SUBJECT: SAFETY EVALUATION REPORT ON EPRI TOPICAL REPORT NP-7450(P),  
REVISION 4, "RETRAN-3D - A PROGRAM FOR TRANSIENT THERMAL-  
HYDRAULIC ANALYSIS OF COMPLEX FLUID FLOW SYSTEMS" (TAC NO.  
MA4311)

SAFETY EVALUATION BY THE OFFICE OF NUCLEAR REACTOR REGULATION  
RELATED TO EPRI NP-7450(P), "RETRAN-3D - A PROGRAM FOR TRANSIENT  
THERMAL-HYDRAULIC ANALYSIS OF COMPLEX FLUID FLOW SYSTEMS"

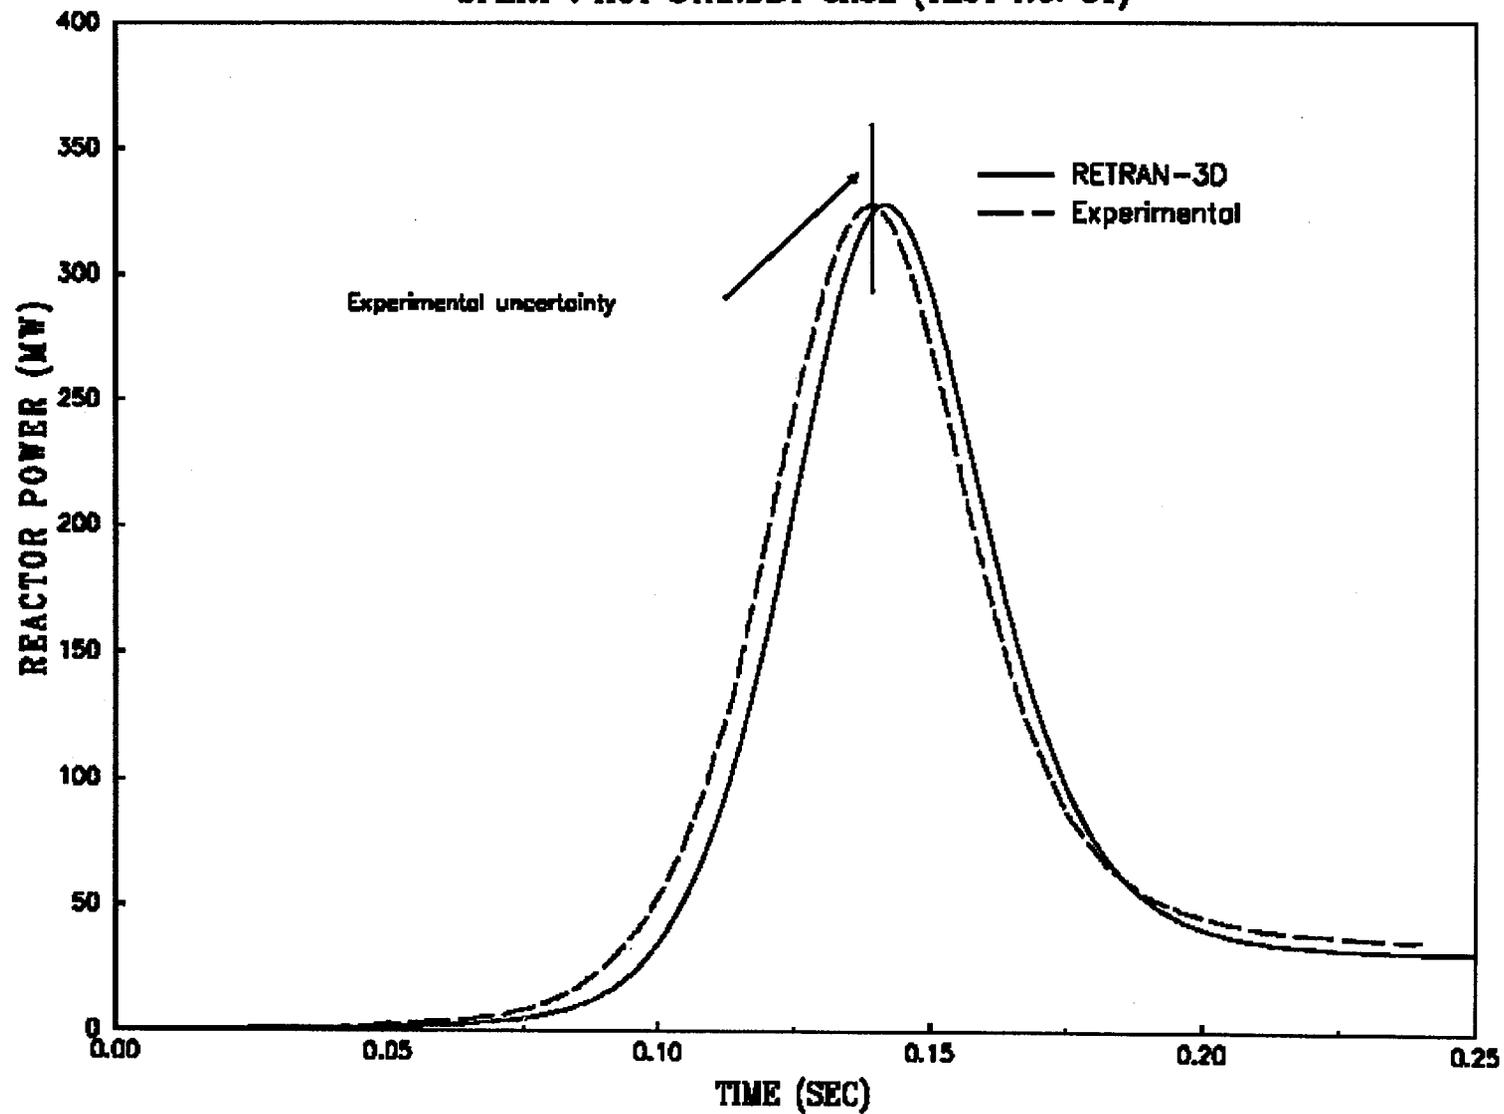
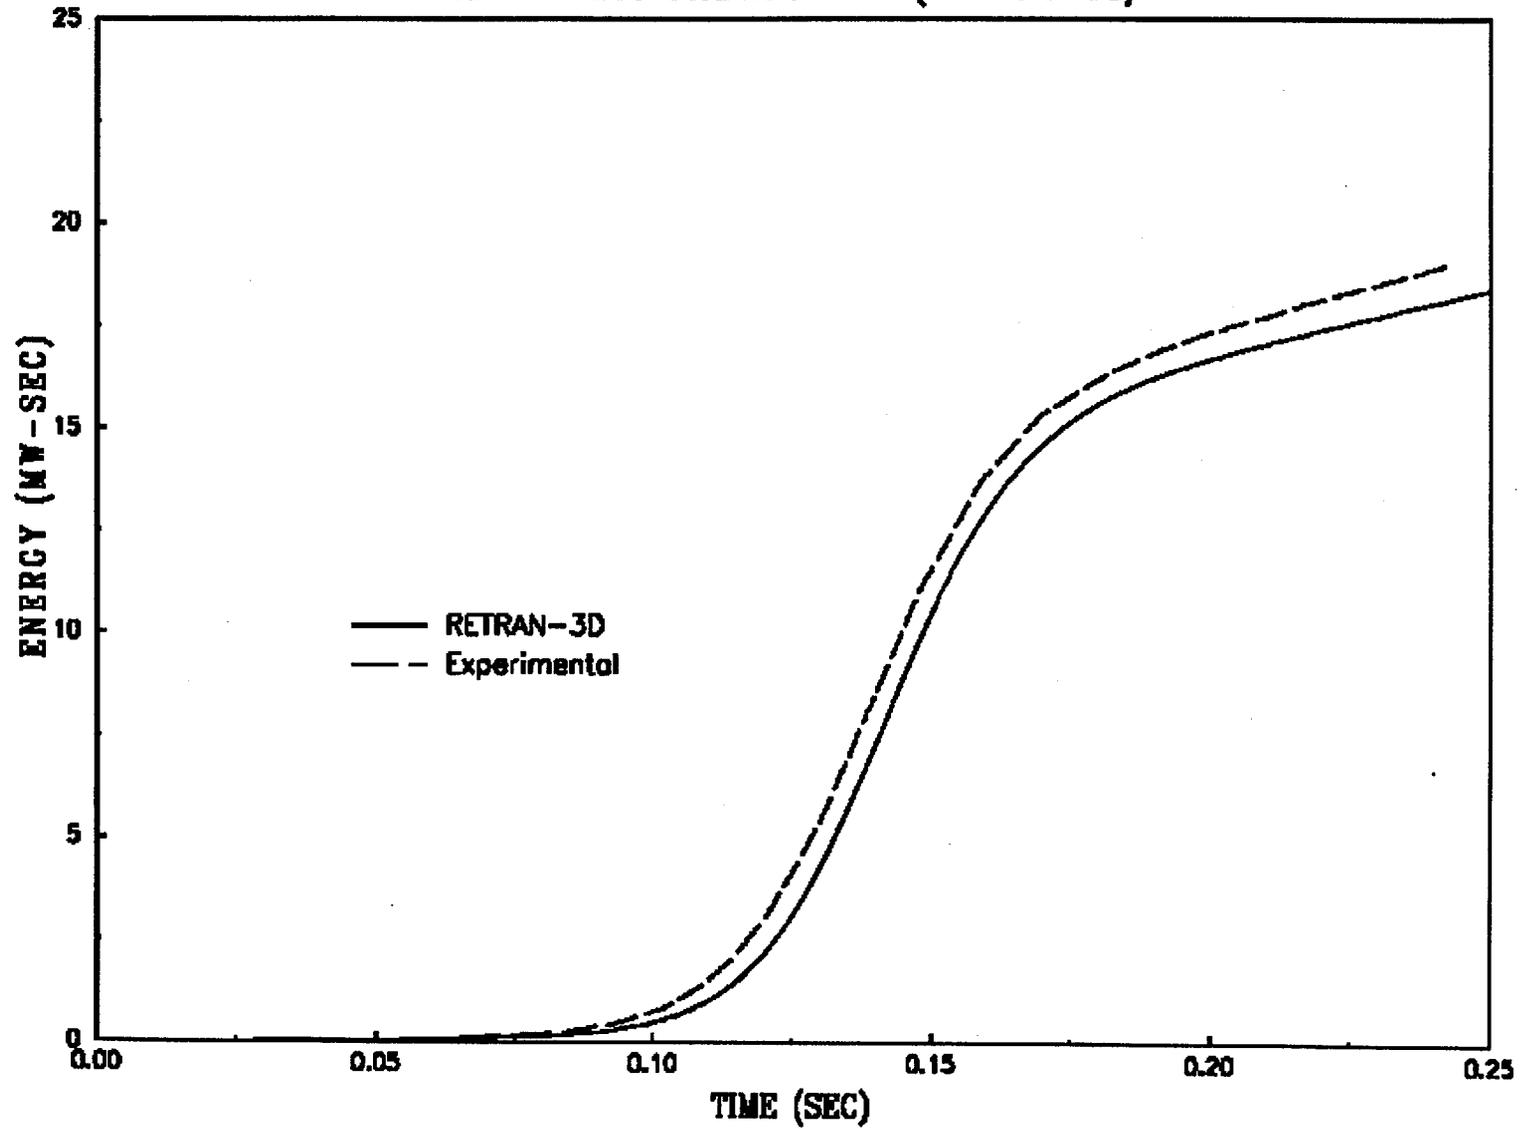
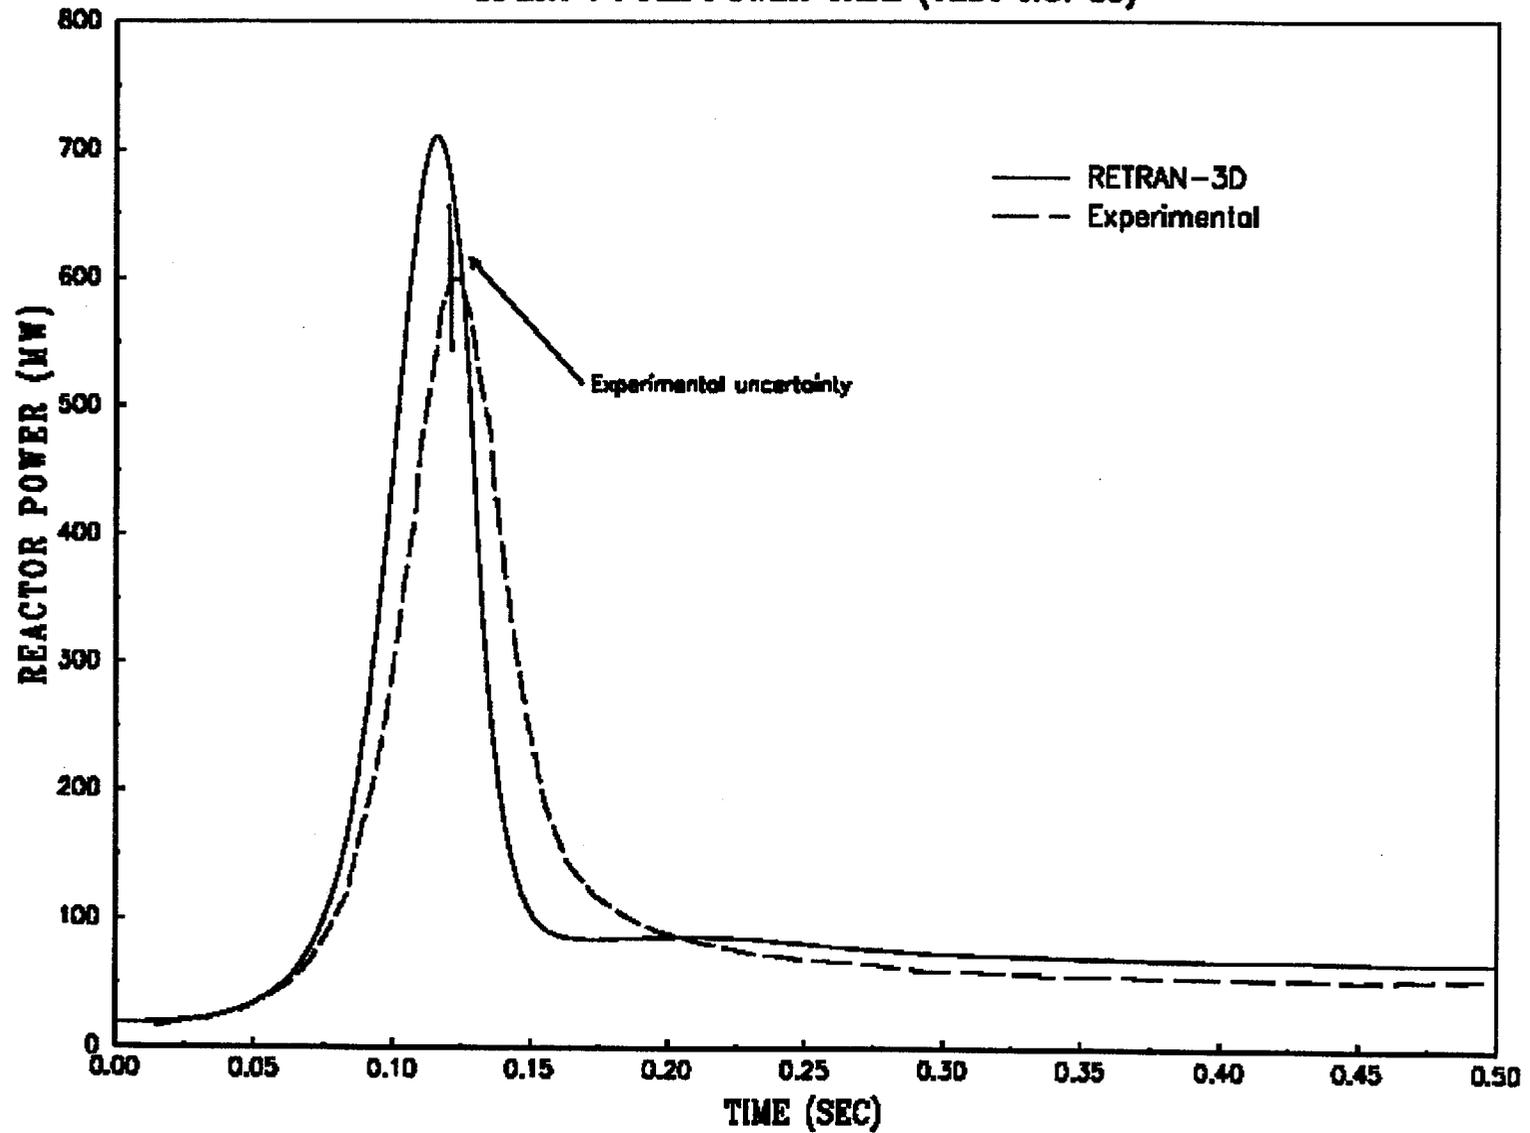
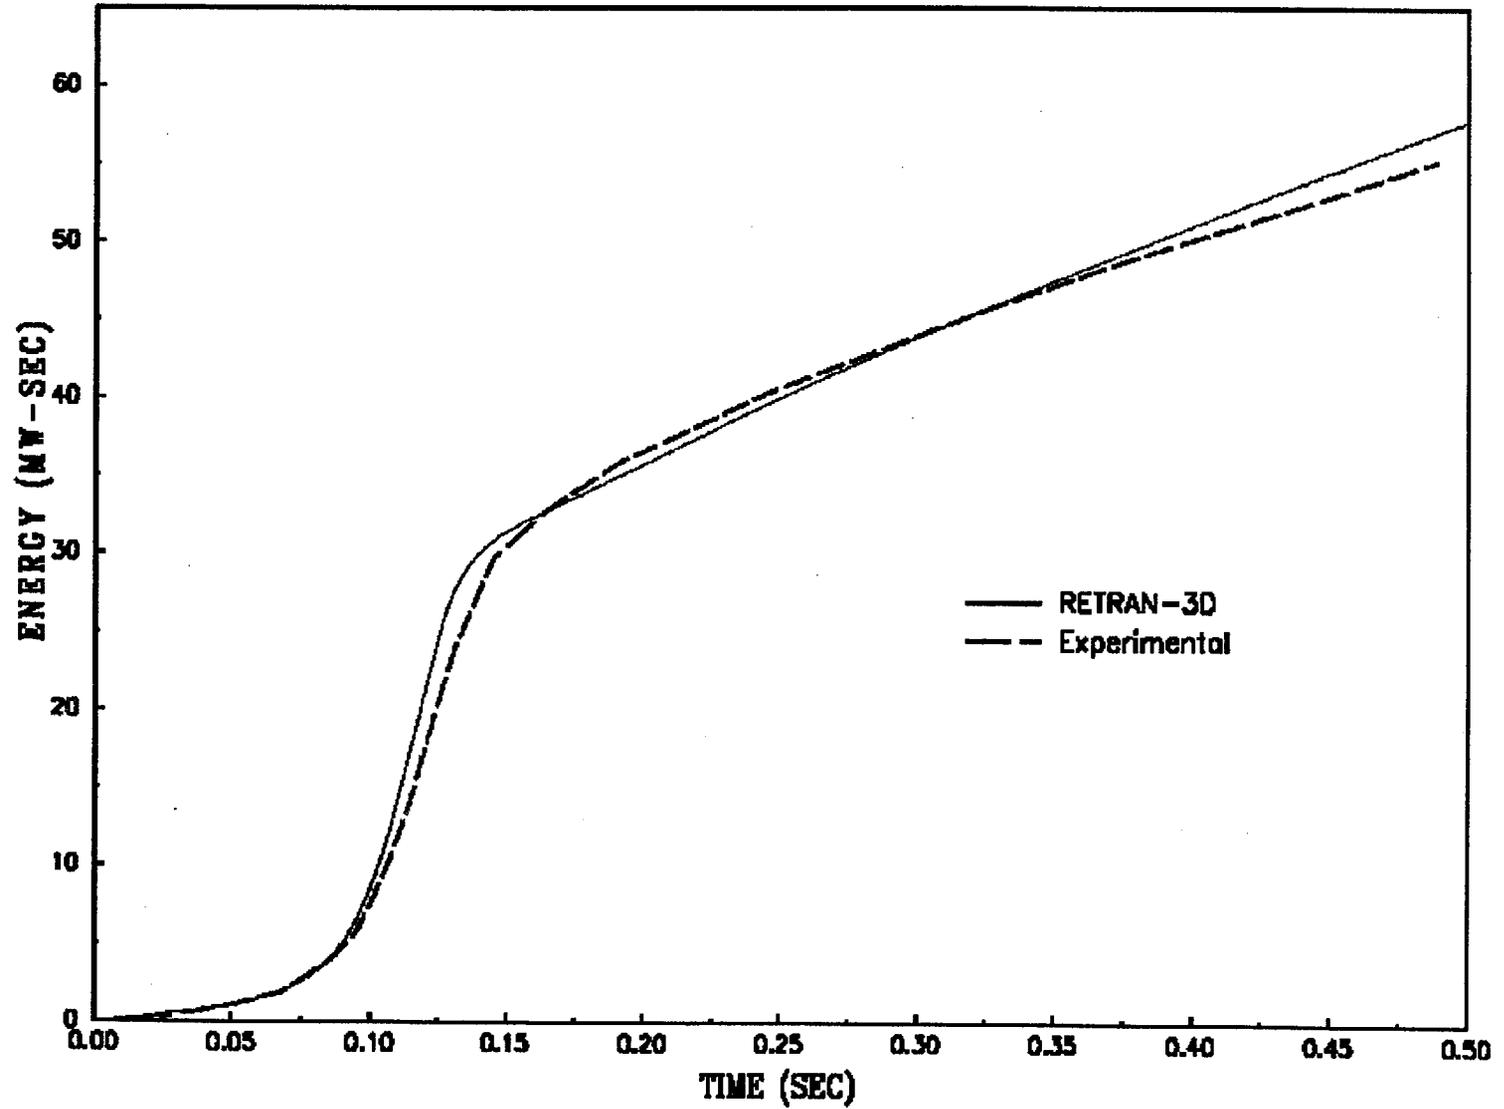
information were provided to EPRI to assist their prediction of the SPERT tests with RETRAN-3D. Figures 3 through 6 show that RETRAN-3D also accurately predicted the test results.

Figure A.1 Radially Averaged Axial Power Distributions

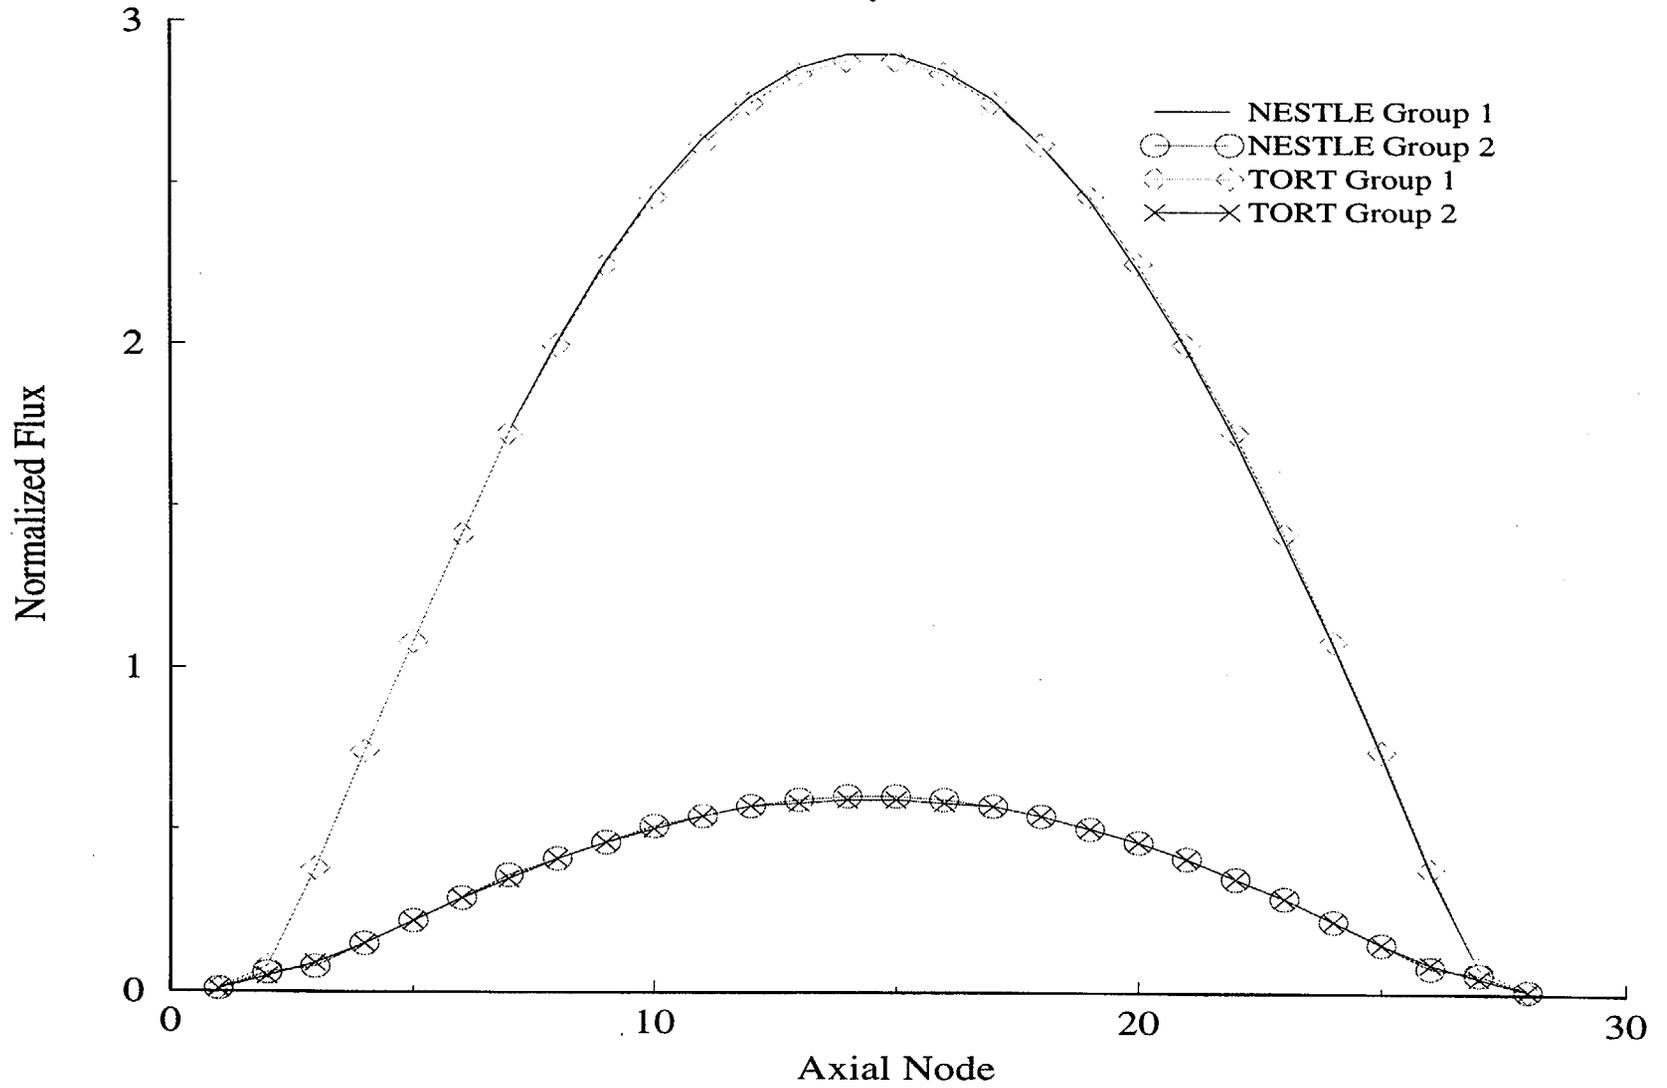
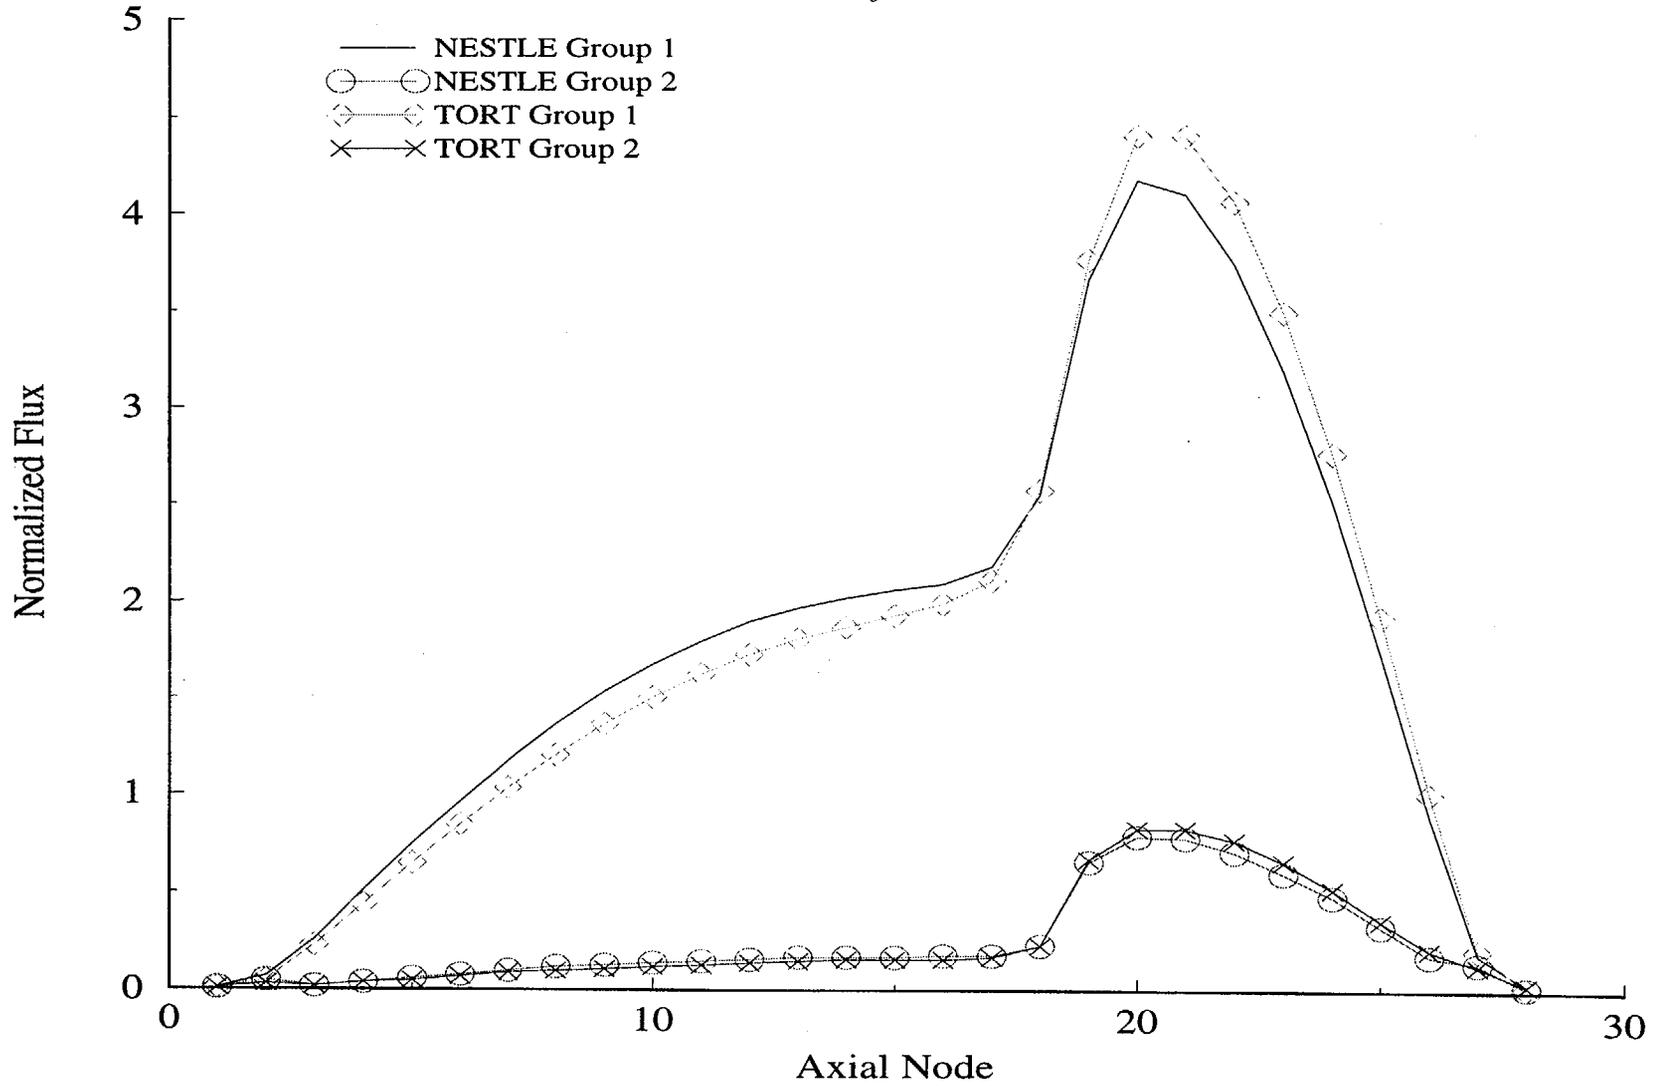
Two plots were created and presented as Figures A.1 and A.2. Figure A.1 shows the axial power distribution averaged for all of the fuel. As expected, the flux follows the familiar cosine shape and the fast (or group 1) flux has a larger magnitude. The TORT and NESTLE predictions are in excellent agreement. Figure A.2 shows the axial flux profiles for the assembly where the  $B_4C$  control rod is inserted. This case is much more challenging due to the presence of the strong absorber, but the diffusion theory code still predicts acceptable results with a maximum error of 6 percent for the fast flux. This is considered excellent given that theoretically diffusion theory breaks down in the presence of strong absorbers such as  $B_4C$ .
